USER NAME: <i>mkawir</i>	DESIGNED: <i>SJM</i>	REVISED: -
DRAWN: <i>SJM</i>	CHECKED: <i>SPG</i>	REVISED: -
PLT SCALE: 1" = 40'	DATE: 12/28/12	ADDENDUM 1

NAVAIDS
RW 22L MALSR RELOCATION
EXISTING SITE PLAN

F.A.P. RTE. 330	SECTION 0105 WRS&HB	COUNTY COOK	TOTAL SHEETS 605	SHEET NO. 605AJ
CONTRACT NO. 60637				ILLINOIS FED. AID PROJECT

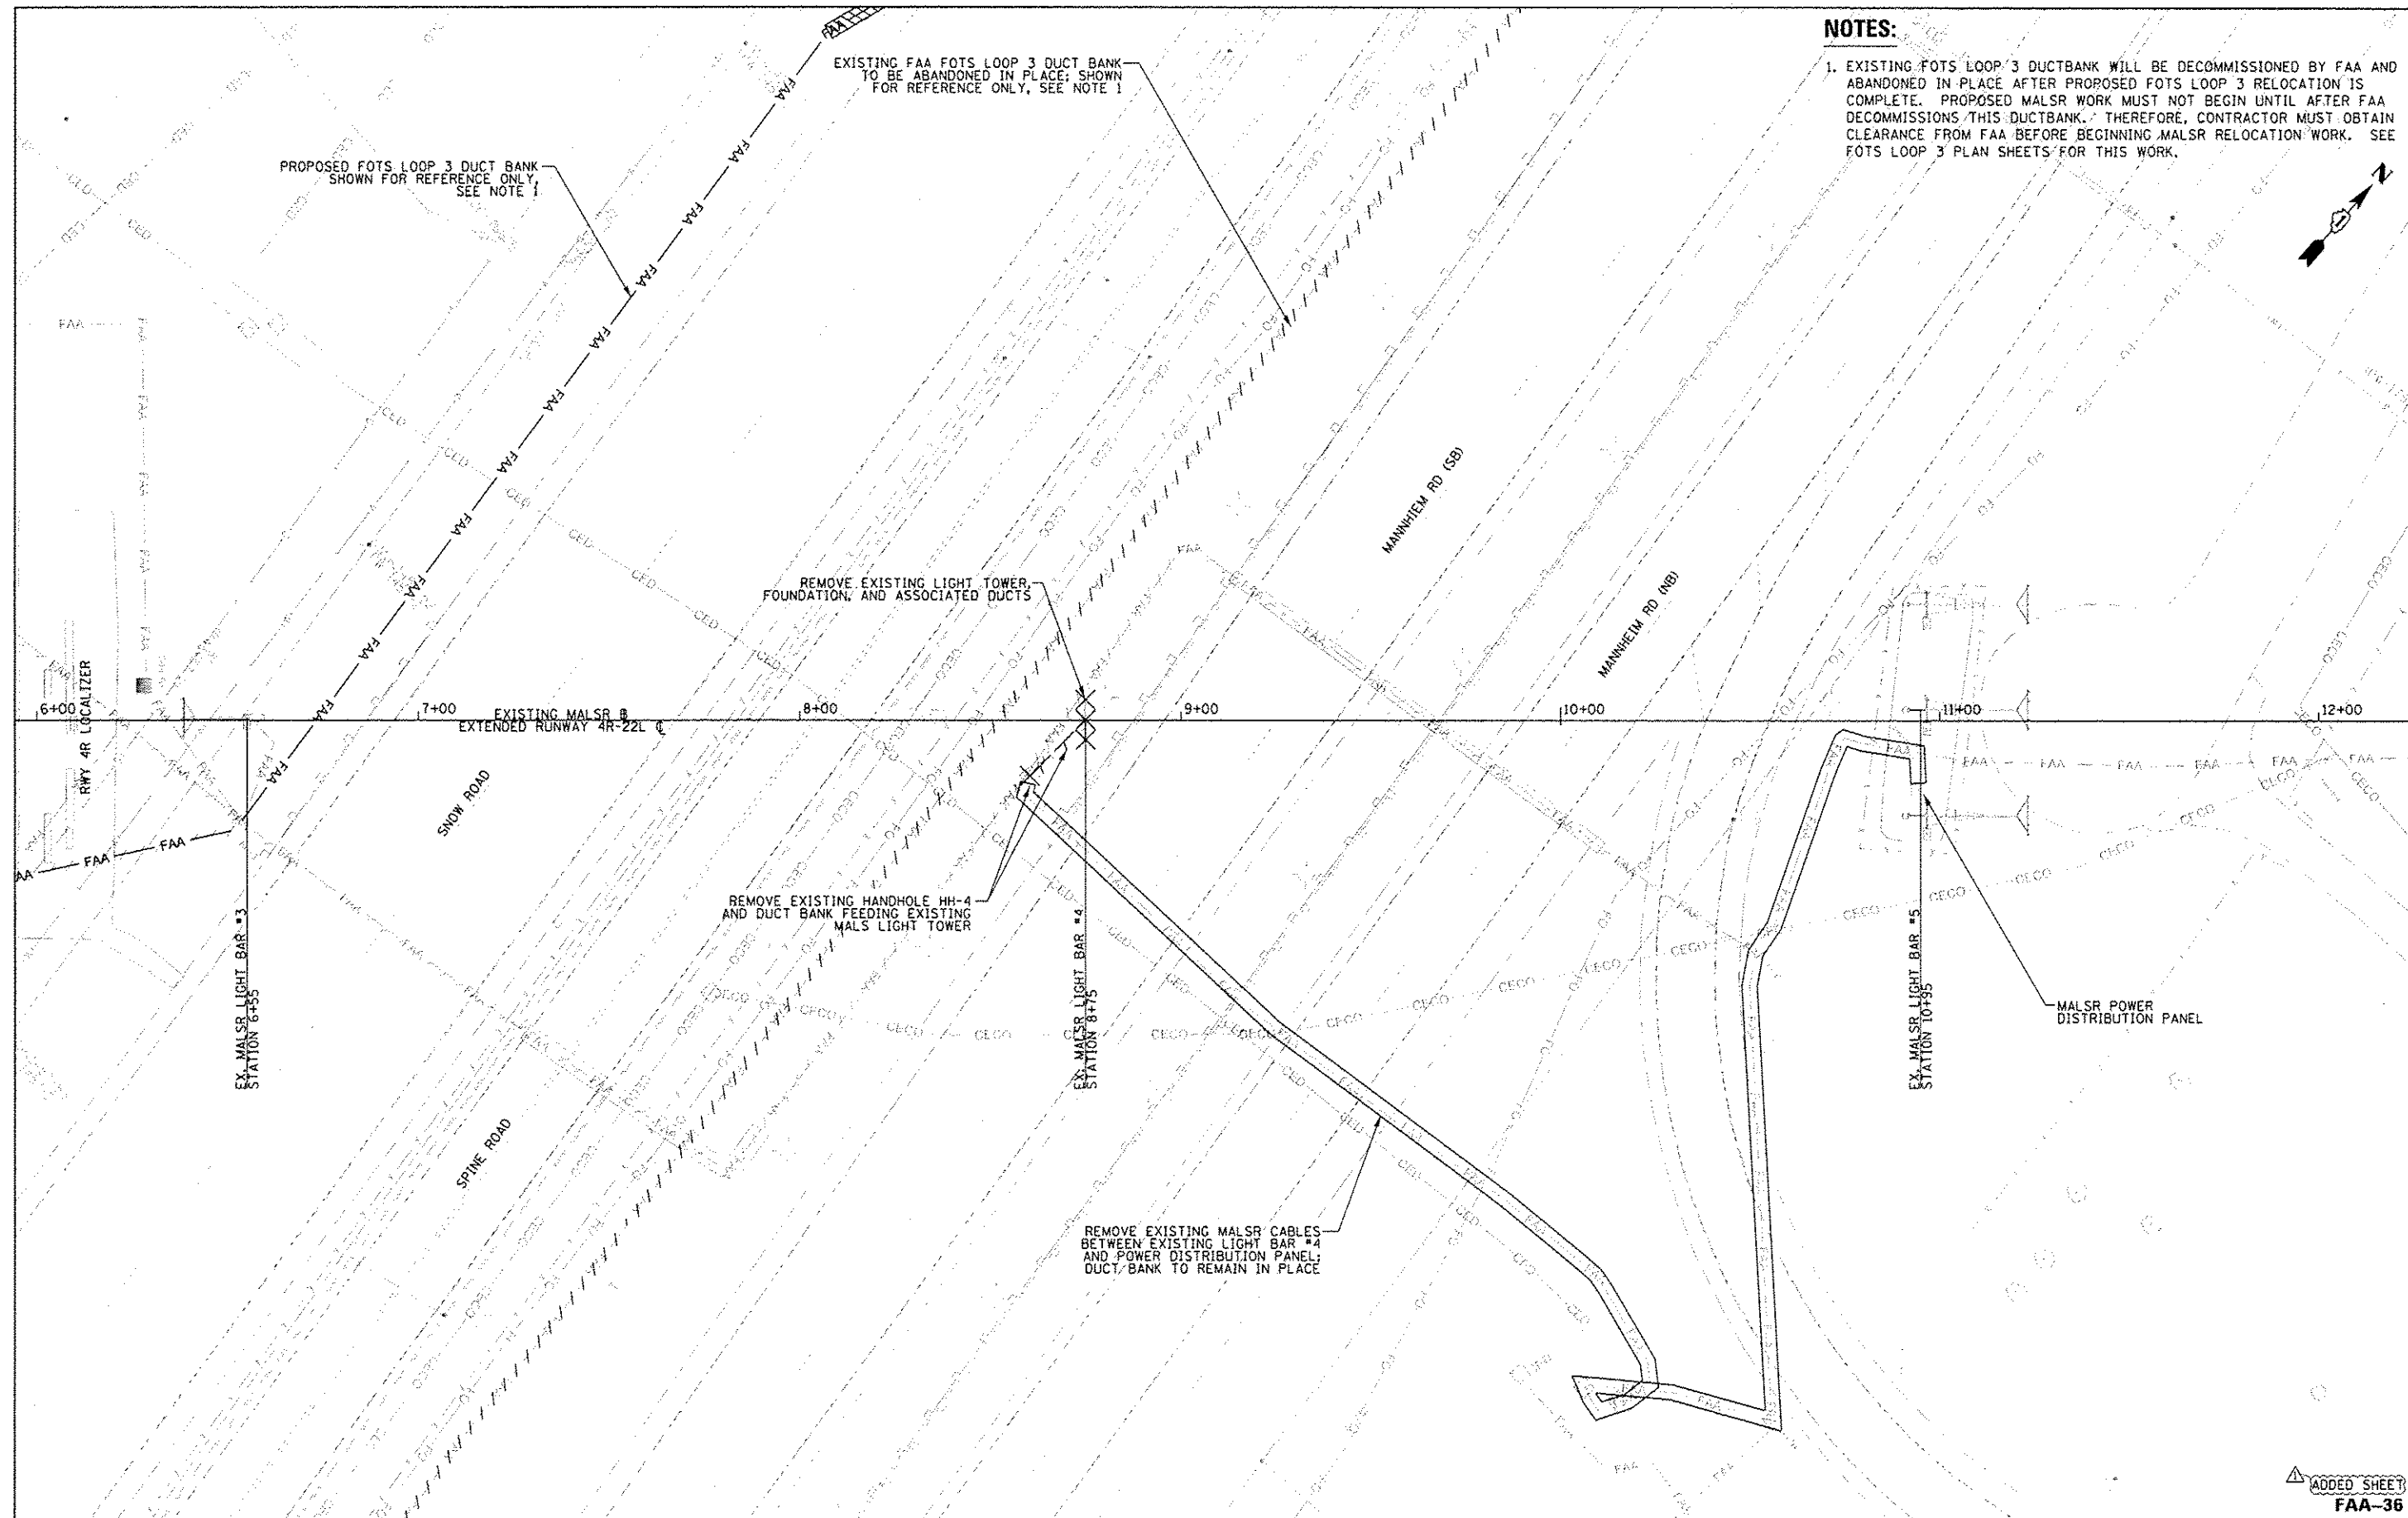
- NOTES:**
1. EXISTING FOTS LOOP 3 DUCTBANK WILL BE DECOMMISSIONED BY FAA AND ABANDONED IN PLACE AFTER PROPOSED FOTS LOOP 3 RELOCATION IS COMPLETE. PROPOSED MALSR WORK MUST NOT BEGIN UNTIL AFTER FAA DECOMMISSIONS THIS DUCTBANK. THEREFORE, CONTRACTOR MUST OBTAIN CLEARANCE FROM FAA BEFORE BEGINNING MALSR RELOCATION WORK. SEE FOTS LOOP 3 PLAN SHEETS FOR THIS WORK.
